# SERVICE BULLETIN # 00140

**SUBJECT:** Installation of 20 oz. "Straight-Wall" Plastic Bottle Bridging in GII Venders

**MODELS:** 804-9 & 660-9 (GIII Models)

## Left Column Wall

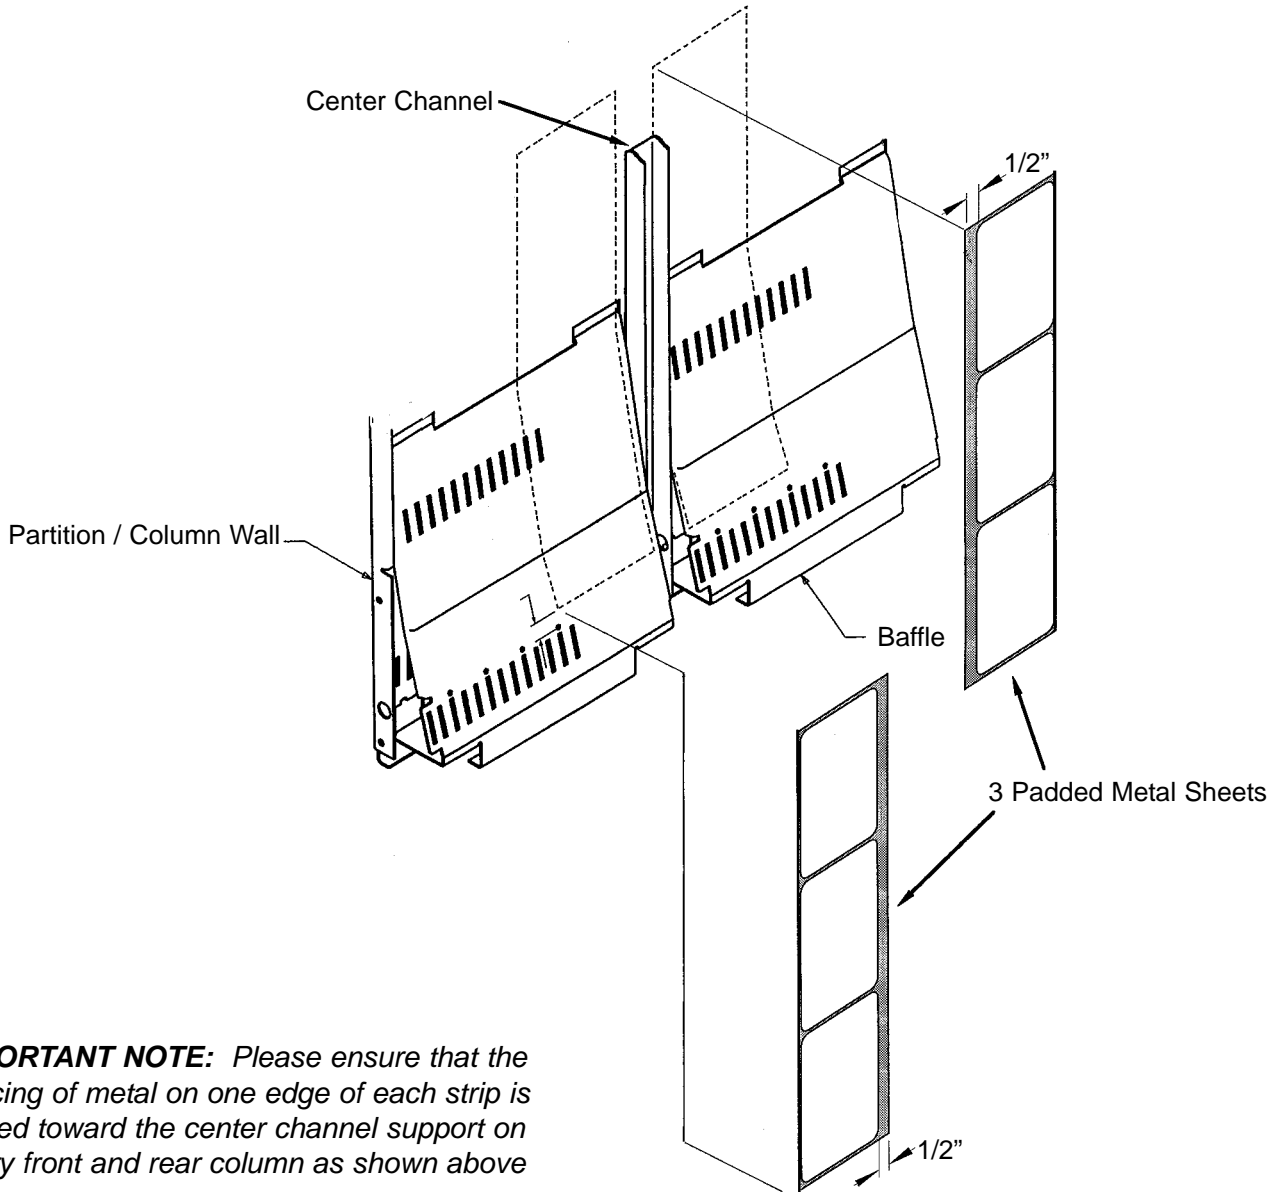
1. Unload column to be retrofitted.
2. Peel the backing from the 3 pieces of the "two-sided" tape on the rear of the 3 padded metal sheets.
3. Place the 3 padded metal sheets on the column wall against the center channel (divider between the front and rear columns). Make sure that the edge of the 3 padded metal sheets with 1/2" of metal exposed is aligned against the center channel as shown in the diagrams on page 2 and 3 of this bulletin. Locate the bottom edge of the sheet approximately 1" above the bottom product retainer slots on both right and left column walls as shown in the diagrams on page 2 and 3 of this bulletin.

**IMPORTANT NOTE:** Please ensure that the spacing of metal on one edge of each strip is placed toward the center channel support on every front and rear column as shown above

## Right Column Wall

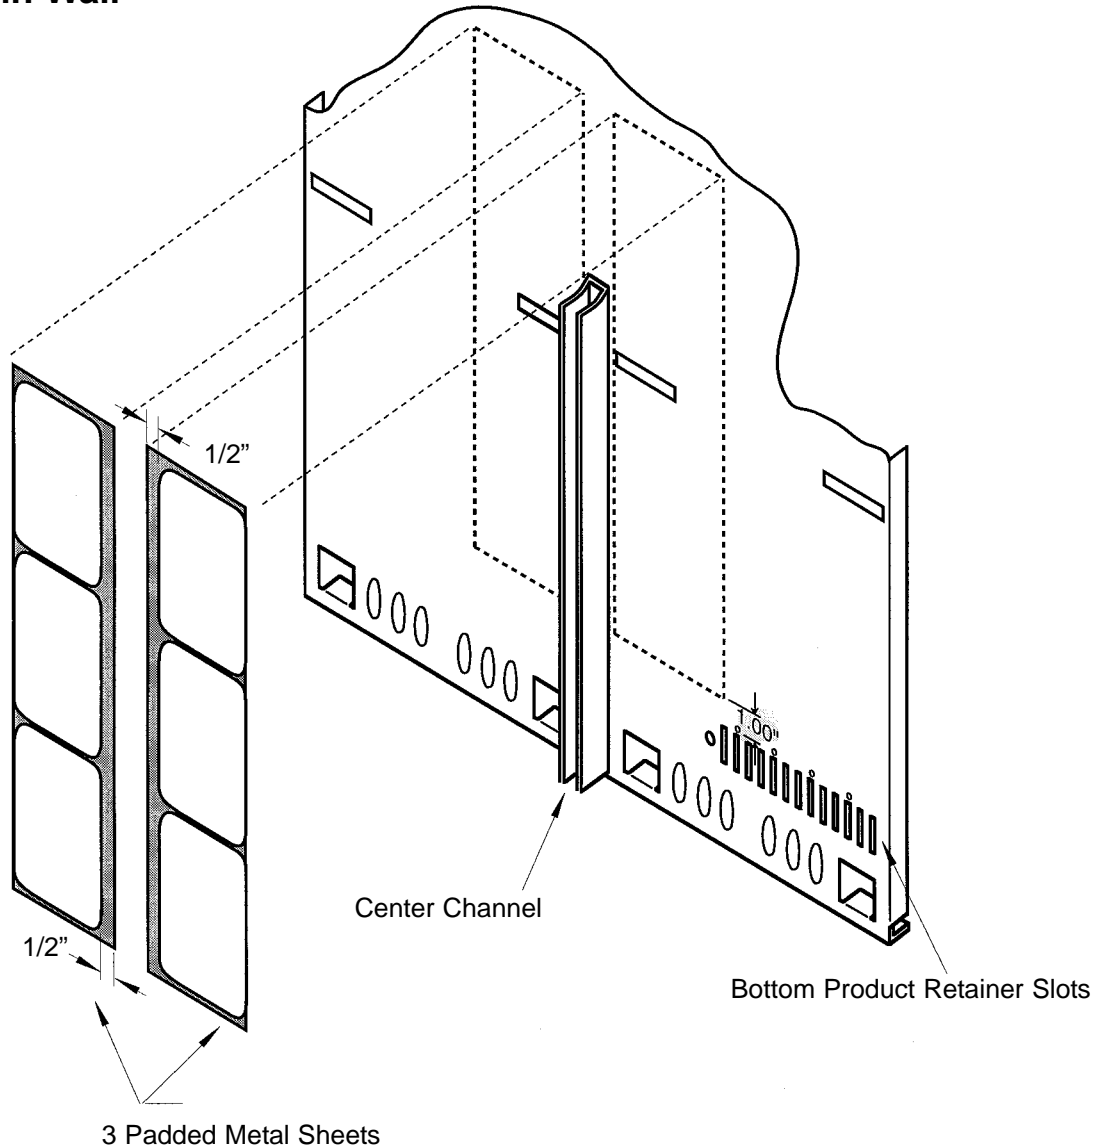
**IMPORTANT NOTE:** Please ensure that the 1/2" spacing of metal on one edge of each strip is placed toward the center channel support on every front and rear column as shown above.
